RE: Jade Building, 41 Weld Street, Hokitika

I have completed a more detailed review of the DSA for the Jade building, 41 Weld Street, Hokitika.

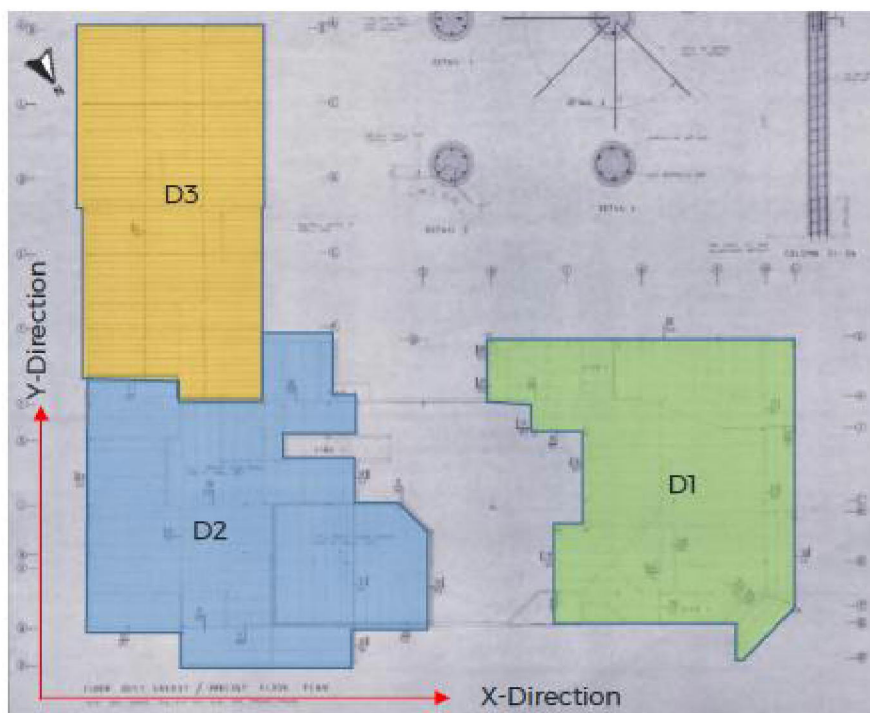
My review has been of the newer buildings (D1 and D2 on the drawing below) on the site, and a "guestimate" for the upper floor of the older building (D3). I do not have any detail about the original concrete building that forms the lower storey of D3 so have not been able to advance that at this stage.

In my opinion buildings D1 and D2 will achieve a minimum 67% NBS at IL 2 with only minimal strengthening work. That strengthening is to improve the seating details for the precast flooring units on their supporting structure. **Redacted under s 7(b)(ii) LGOIMA** The additional seating is a precautionary detail, and hence the building is still currently rated at 67% NBS in my opinion.

Building D3 consists of an original single storey concrete perimeter wall structure which was strengthened by adding portal frames across the building. Those new portal frames supported a timber floor at first floor level and a lightweight roof. As noted above, I do not have any details as to the construction of the concrete walls. I have made some assumptions relating to these walls for the overall portal frame check. That check has confirmed that some strengthening is needed for the upper section of the portal frames. The lower floor cannot be properly analysed until the construction of the concrete walls is confirmed. **Redacted under s 7(b)(ii) LGOIMA**
